Hubbell Realty Company - 510 SW 9th Street - PUD Amendment ZON2013-00001

Request from Hubbell Realty Company (developer) represented by Steve Niebuhr (officer) for review and approval of an amendment to the Riverpoint Flex Office Park West PUD Conceptual Plan on property located at 510 Southwest 9 <sup>th</sup> Street. The subject property is owned by 510 SW 9 <sup>th</sup> Street, LLC.			File # <b>ZON2013-00001</b>		
<b>Description of Action</b>	Approval of an amendment to the Riverpoint Flex Office Park West PUD Conceptual Plan on property located at 510 Southwest 9 <sup>th</sup> Street, to allow development of 10.5 acres of vacant land for development of nine (9) mixed-use four-story buildings with a total of 339 residential units on floors 2-4, 4,554 square feet of clubhouse, and up to 85,485 square feet of first-floor commercial space with an option of 92 first-floor parking spaces in lieu of 35,577 square feet of commercial space subject to conditions.

**PRELIMINARY CONCEPTUAL PLAN FOR RIVERPOINT FLEX OFFICE PARK WEST**  
 A PLANNED UNIT DEVELOPMENT IN THE CITY OF DES MOINES, COUNTY OF POLK, STATE OF IOWA  
 SHEET 2.2 OF 6  
 AMENDMENT #2

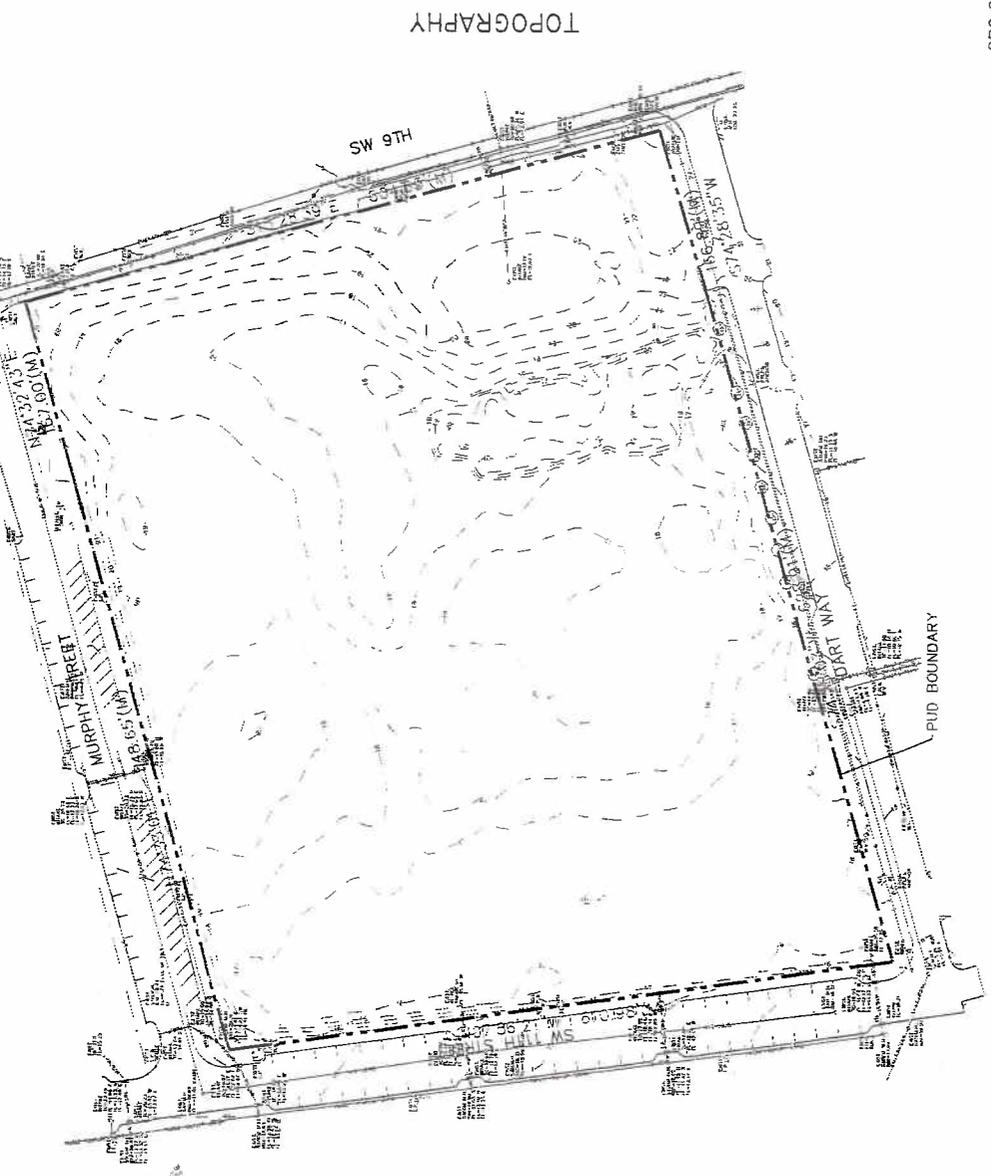
*The applicant is proposing a 2-foot building setback from SW 11<sup>th</sup> Street and Murphy Street. A 90-foot building setback is proposed along SW 9<sup>th</sup> Street. A 12-foot building setback is proposed along DART Way. The site is surrounded by "C-3B" and "C-3A" zoning districts. For comparison, the "C-3B" District design guidelines require a minimum of 70 percent of the building frontage be set within one foot of the front lot line for commercial buildings. The "C-3A" District has no building setback requirements. Staff believes that the proposed setbacks are appropriate for the character of the area.*

*The submitted conceptual plan indicates that storm water would be handled by "a combination of conventional detention and conservation practices, which may involve permeable pavements, infiltration trenches, groundwater recharge pits, rain gardens or other methods." Sanitary sewer is available in SW 9<sup>th</sup> Street, Murphy Street, SW 11<sup>th</sup> Street and the west 300 feet of Dart Way. The Permit and Development Center has requested that the approximate locations of storm water facilities be identified on the Conceptual Plan.*

*The submitted Conceptual Plan identifies 402 off-street parking spaces and 52 on-street spaces that adjoin the site.*

*The Conceptual Plan shows an open green space in the middle of the development that would include a fenced dog park feature.*

*The "What's Next Downtown Plan" envisions a dense and pedestrian friendly downtown. The proposed four-story building type and mix of uses is appropriate for this area along the southern perimeter of the downtown. The proposed layout of the site speaks to the auto-oriented nature of the adjoining segment of SW 9<sup>th</sup> Street and to the pedestrian orientation envisioned for the SW 11<sup>th</sup> Street corridor.*

1. Prohibition of the following uses:
  - a. Mobile home parks.
  - b. Used car lots.
  - c. Adult entertainment businesses.
  - d. Automobile washing and oil changing establishments.
  - e. Automobile body and fender repair shops.
  - f. Communications tower/antenna (unless as an extension of 20 feet or less from a structure).
  - g. Convenience stores with fuel sales.
  - h. Delayed deposit services.
  - i. Pawn brokers.
  - j. Off-premise advertising signs.
2. Identification of the approximate location of storm water facilities on the Conceptual Plan.
3. Compliance with the "C-3" District Landscaping Standards.
